Service Bulletin

Subject: FreshBlender Door Adjustment

SCOPE: ALL MULTIPLEX FreshBlender MACHINES

Symptom

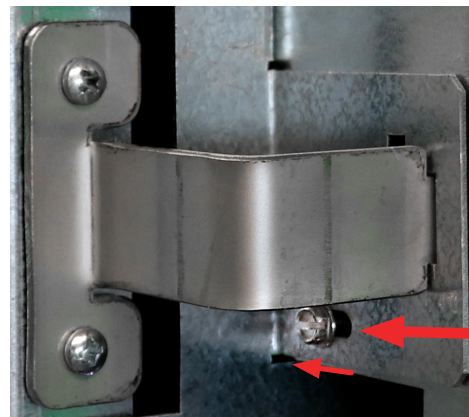
FreshBlender top door will not close or will not close without force.

FreshBlender top door latch will not slide under the top door catch or will slide with extreme difficulty. Catch adjustment or adding a door shim will solve issue.

Top Door Catch

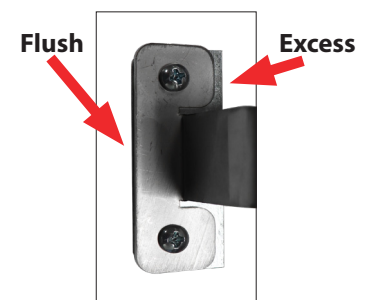
1. Make sure the slot on the catch is all the way forward.

**Shim
WBL-92-122**

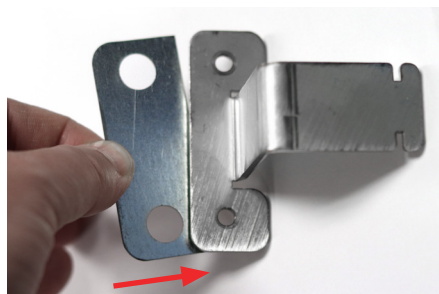
2. If difficulty persists, installing one or two shims (part number WBL-92-122) under the top door catch will resolve the issue.
 - A. Remove screws from top door catch.
 - B. Slide one or two shims under top door catch.
 - C. Re-install screws in top door catch and shims. Ensure shims line up left of catch to prevent overhang.
